Re: U.S. Patent Application Serial No.: 09/650,969
Filed: August 29, 2000
Confirmation No.: 8650
Notice of Allowance Mailed: March 29, 2004
Title: NEAR FIELD OPTICAL APPARATUS
Inventor: Robert L. THORNTON et al.
Our File No.: ST 2622.01 US

For: Near Field Optical Apparatus

**PETITION TO WITHDRAW HOLDING OF ABANDONMENT
UNDER 37 C.F.R. § 1.181 (a)**

Fig. 27 (PRIOR ART)

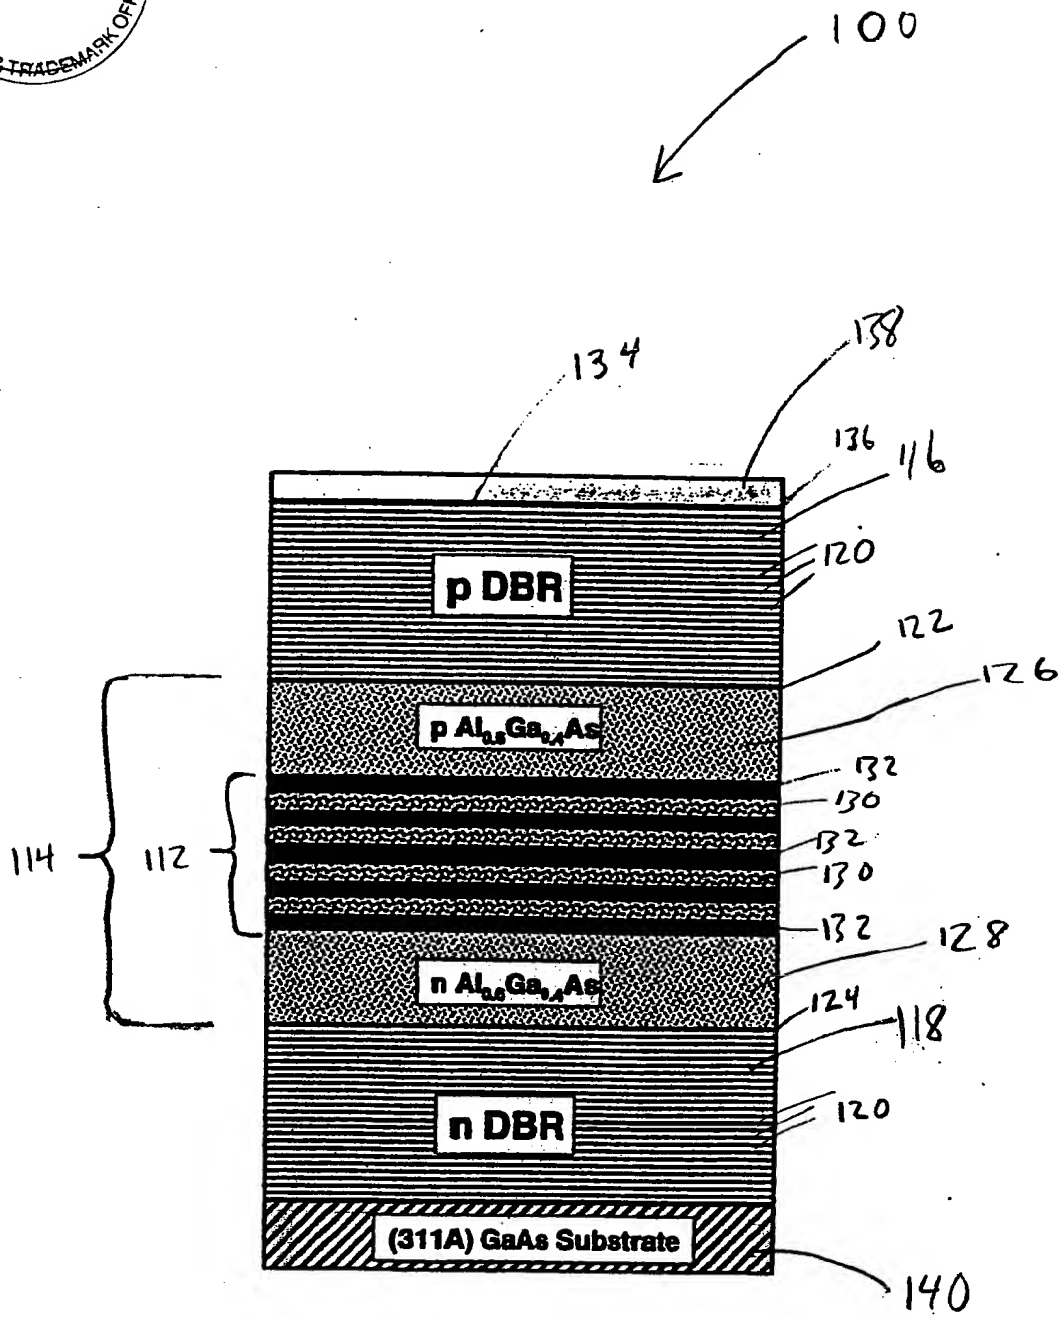
- a) The Office action with the mailing date of 04/24/2002 stated that "The drawing(s) filed on 29 August 2000 is objected to by the Examiner" (a copy is attached hereto as Exhibit B). On page 2 of said Office action, the Examiner objected to the drawing because Fig. 29 does not have reference number 118.

The drawings are objected to as failing to comply with 37 CFR 1.84(p)(5) because they do not include the following reference sign(s) mentioned in the description: Figure 29 does not have reference number 118. A proposed drawing correction or corrected drawings are required in reply to the Office action to avoid abandonment of the application. The objection to the drawings will not be held in abeyance.

Submitted herewith for the Examiner's approval are proposed amendments to FIG. 27. The proposed amendments to the figure are indicated thereon in red ink. It is believed that the office action intended to imply that FIG. 27 was in error not FIG. 29.

The FIG. 27 has been amended to correct the numeral "18" and provide the proper reference numeral "118." Entry of the amendments is respectfully requested.

Fig. 27 (PRIOR ART)

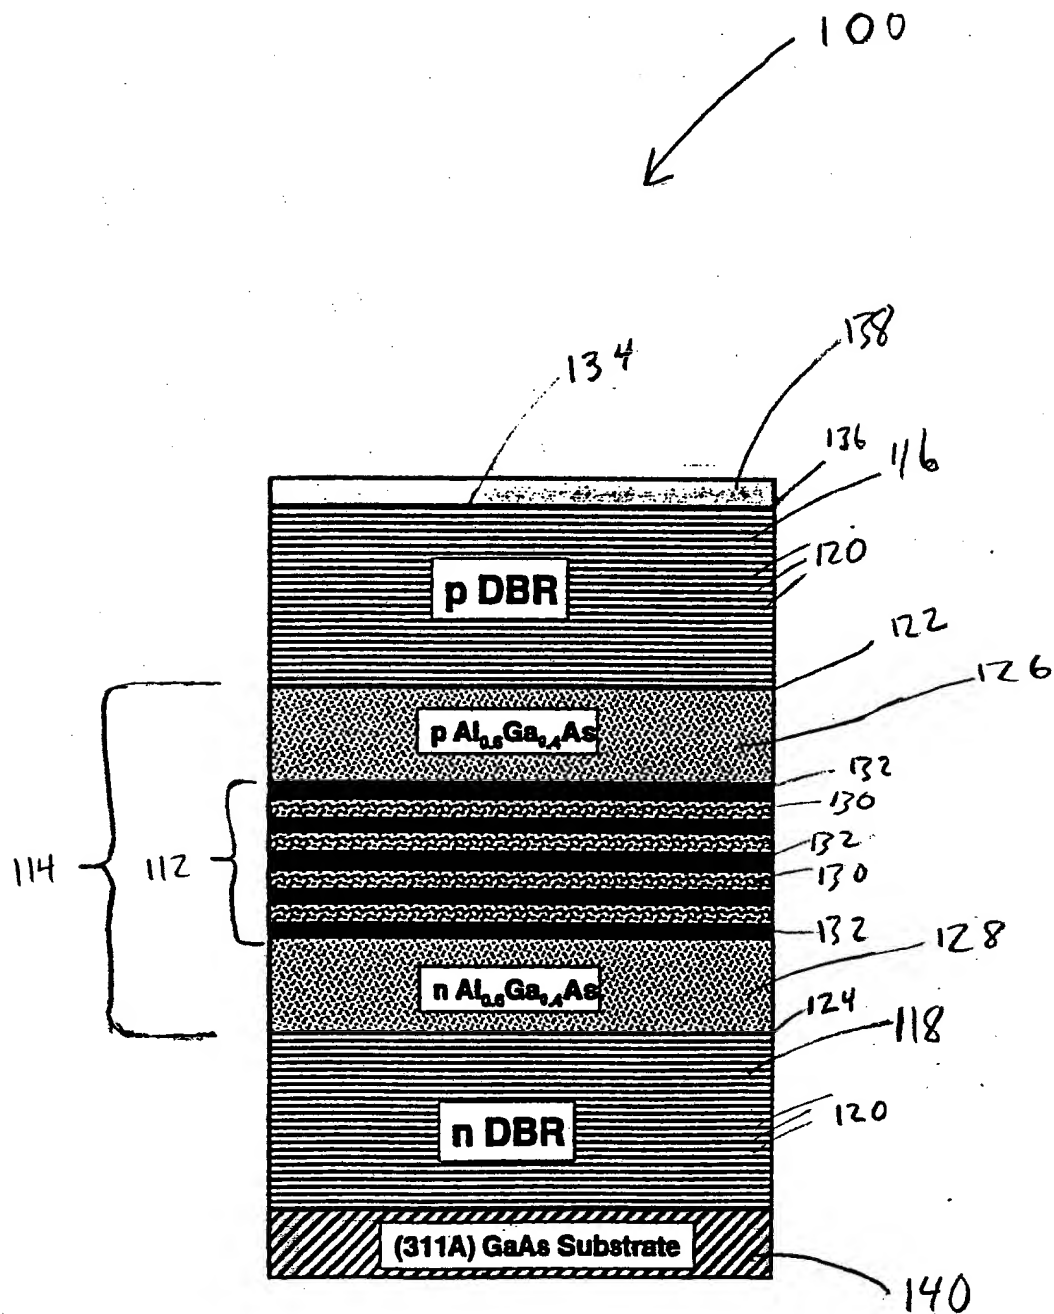
- b) A Response, which included the corrected drawing, was filed on October 24, 2002. As stated in the Response, it is believed that the Office action intended to imply that Fig. 27 was in error not Fig. 29 (a copy of the Response and the filing receipt are attached hereto as Exhibit C).

9. In the alternative, it is respectfully submitted the corrected drawing(s) herein as attachment 1.
